Datasheet Correction : TMPM375FSDMG

TMPM375FSDMG

TMPM375FSDMG_datasheet_en_20141126.pdf

20.3.3 ▪▪▪ Page 518

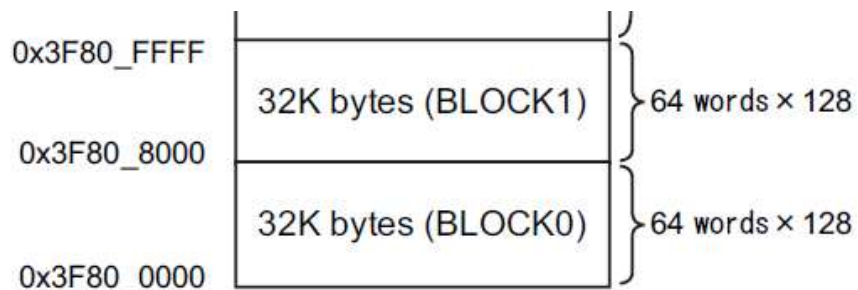
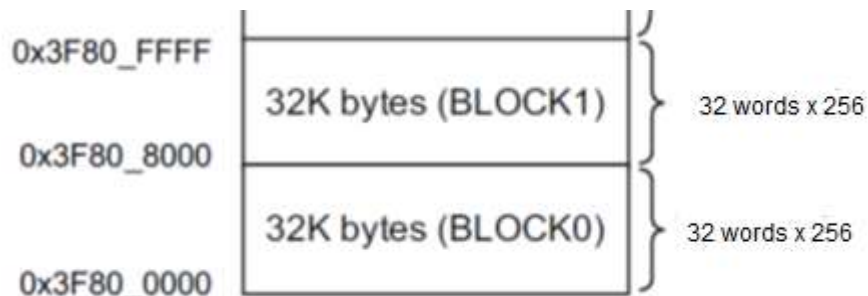
[Correction(4)]

before)

・ In case of rounding down OFDMXPLLON/OFDMXPLLOFF and **rouding down** OFDMNPLLON/OFDMNPLLOFF

after)

・ In case of rounding down OFDMXPLLON/OFDMXPLLOFF and **rounding up** OFDMNPLLON/OFDMNPLLOFF
